ADVISORY REPORT

File: SAR16-01828 & SEP16-01580

1. Applicant: Jay Schlau
2. Site Location: Vacant parcel on 10th St. S., just north of 9th Ave. S. (See Attachment 1)
3. Request: Request for approval of a Reasonable Use Exception permit to allow construction of a single-family residence within a Type 2 wetland buffer in a secondary basin (Moss Bay), see Attachment 2. The proposal includes 3,000 square feet of on-site disturbance, approximately 137 square feet of which is across a portion of the wetland for on-site access purposes, and approximately 2,954 square feet of right-of-way buffer disturbance for access to the property.

FIGURE 1: DEVON LANE REASONABLE USE BUFFER MITIGATION PLAN
PARCEL 012000-0120
KIRKLAND, WASHINGTON

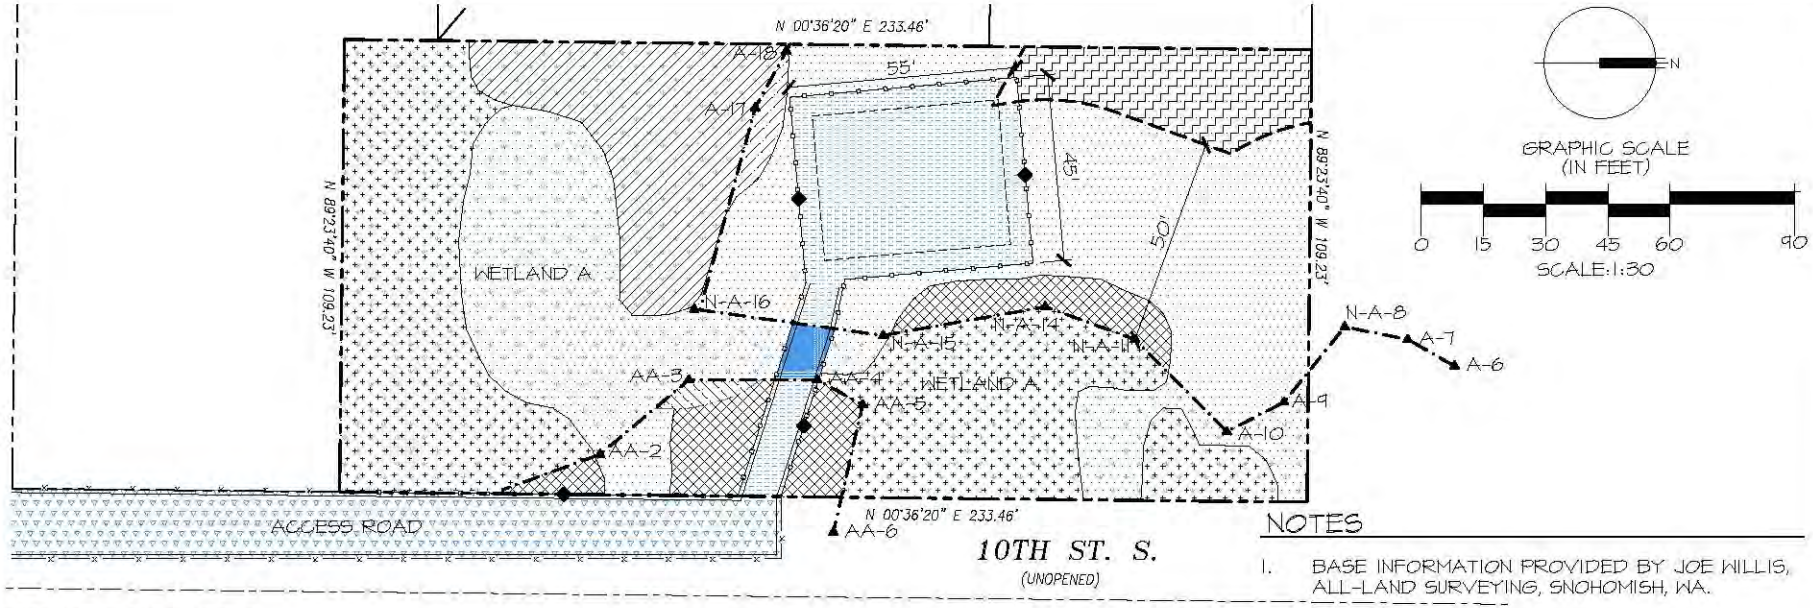
(3) The applicant submitted a preliminary wetland mitigation plan that was reviewed and commented on by The Watershed Company. The plan meets the requirements set forth in Chapter 90, with the exception of providing a bond quantity worksheet.

a. Include in the plan set the approved mitigation, monitoring, and maintenance plans, including the bond quantity worksheet (see Conclusion II.D.8.b.(2).(a)).

c. Submit full erosion control plans, which shall depict the location of a six-foot high construction phase fence along the boundary of the entire sensitive area buffer with silt screen fabric installed per City standard. The fencing shall be installed prior to issuance of any permits. The fence shall remain upright in the approved location for the duration of development activities (See Conclusion II.D.8.b.(2).(b)).

C2.0

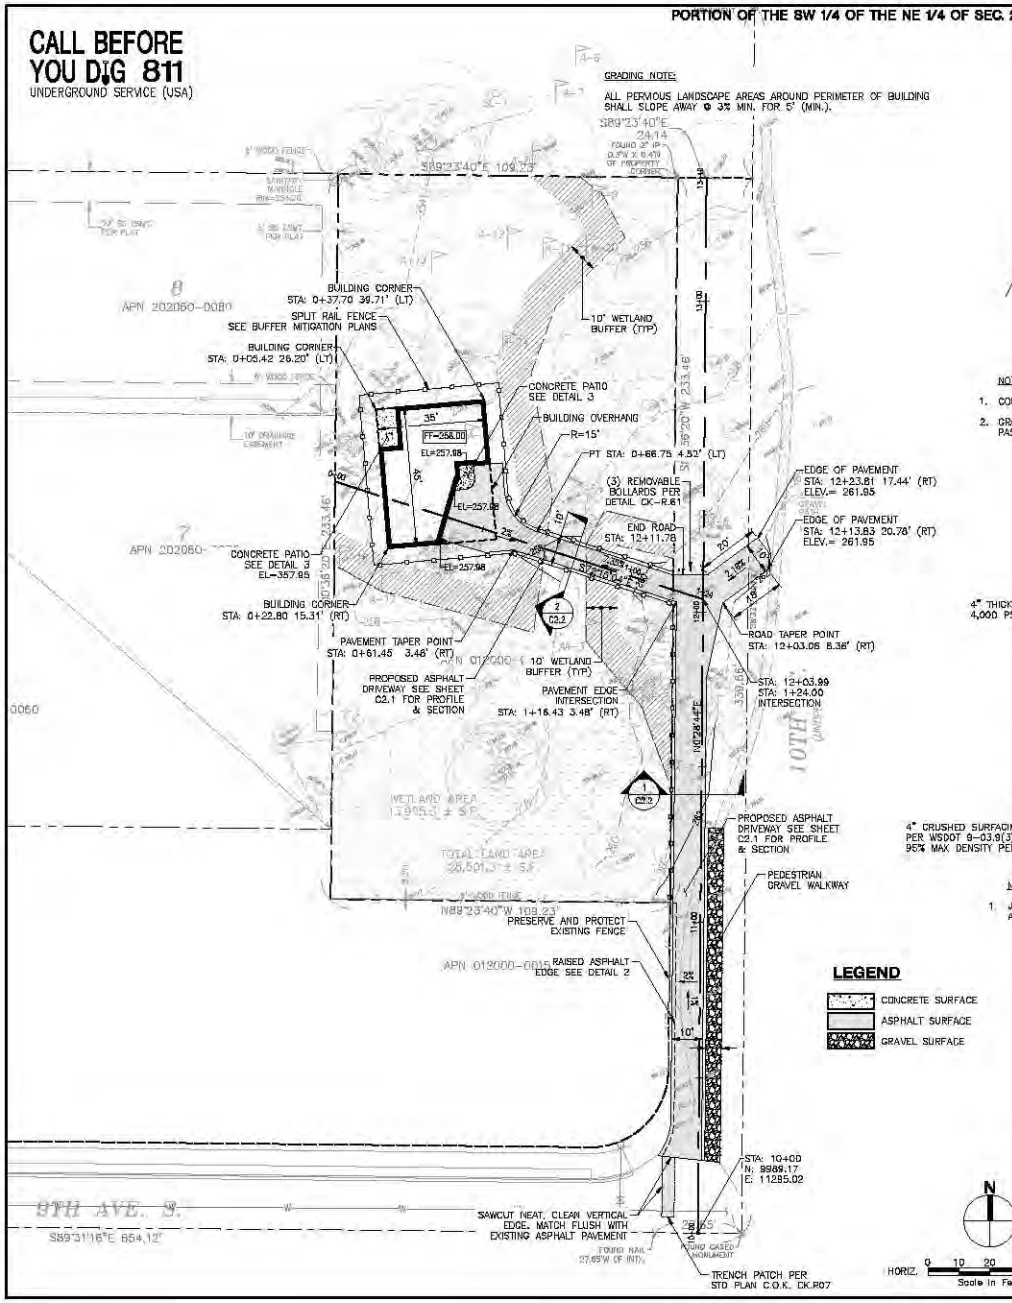
Attachment 2). The garage doors are shown to be recessed by about eight feet at the southeast corner of the building. This is not sufficient depth to back a car out and turn around on-site. The site plan shows an approximately 50 foot long driveway with a vehicular turn around in the 10th Street South right-of-way.

(2) Prior to the issuance of the building permit, the applicant should revise the plans to accommodate a driveway configuration sufficient for entering and existing the property without the need to back out from the garage to the right of way.

(5) The applicant plans show an asphalt driveway within the 10th Street South right-of-way, 10 feet in width, including a proposed vehicular turn around positioned on the northeast side of the entry point to the property.

(2) Prior to the issuance of the building permit, the applicant should revise the building permit, by removing the vehicular turn around in 10th Street South and show pervious pavement for the driveway's material.

g. Include in the building permit plan set, a re-designed driveway:

(1) Constructed of pervious pavement, according to the City's standards (see Conclusions II.D.6.b.(1-3).

(2) Remove the proposed turn around in 10th Street South (see Conclusion II.D.5.b.(2)).

(3) Provide an on-site driveway configuration sufficient for entering and existing the property without the need to back out from the garage to the right of way (see Conclusion II.D.5.b.(2)).
